# Access Compliance Report

## Public Rights-of-Way

### (Curb Ramps)

Intersection ID: 49239	Main Street: W_SUGAR_CREEK_RD	Cross Street: HUBBARD_FALLS_DR	Location: E
ADA ID: DC0B2BBFD408	Ramp Type: Perp	Initial Pass/Fail: Fail	Overall Compliance: No
		Severity Score: 25

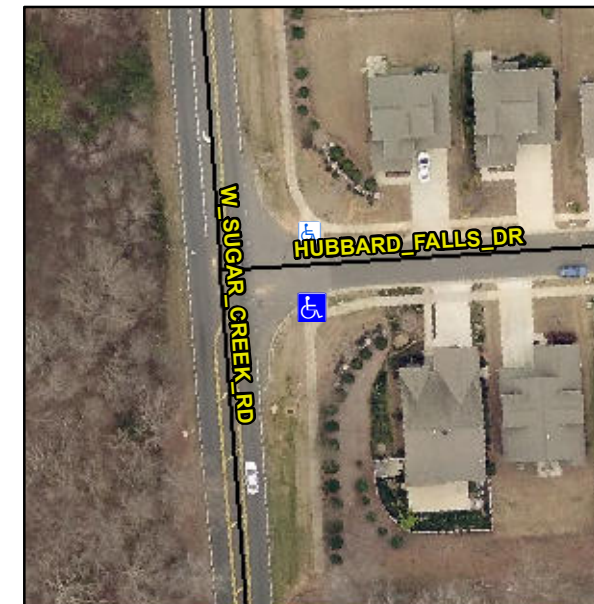
**Not Found, R304.5.3**

Compliance	Description	Data	Compliance	Description	Data
N/A	Ramp Length (in)	63.0	Yes	Ramp Slope (%)	8.0
Yes	Ramp Width (in)	48.0	No	Ramp XSlope (%)	12.2
N/A	Flare Type LT	N/A	N/A	Flare Type RT	N/A
N/A	Flare Slope LT (%)	N/A	N/A	Flare Slope RT (%)	N/A
N/A	Flare Traversable LT?	N/A	N/A	Flare Traversable RT?	N/A
N/A	Landing Length (in)	N/A	N/A	DWS Provided?	N/A
N/A	Landing Width (in)	N/A	N/A	DWS Contrast?	N/A
N/A	Landing Slope (%)	N/A	N/A	DWS Length (in)	N/A
N/A	Landing X Slope (%)	N/A	N/A	DWS Full Width?	N/A
N/A	Landing Curb? (Y/N)	N/A	N/A	DWS Offset (in)	N/A
N/A	Shared Landing?	N/A			
N/A	Gutter Ponding?	N/A	N/A	Gutter Slope (%)	N/A
N/A	Gutter Lip Ht (in)	N/A	N/A	Gutter X Slope (%)	N/A
N/A	Painted X Walk1?	No	N/A	Painted X Walk2?	N/A
	X Walk 1 Direction	To N		X Walk 2 Direction	N/A
N/A	X Walk 1 Width (in)	N/A	N/A	X Walk 2 Width (in)	N/A
	X Walk 1 Slope (%)	4.0		X Walk 2 Slope (%)	N/A
	X Walk 1 X Slope (%)	9.9		X Walk 2 X Slope (%)	N/A

**Remove & Replace Entire Ramp.**
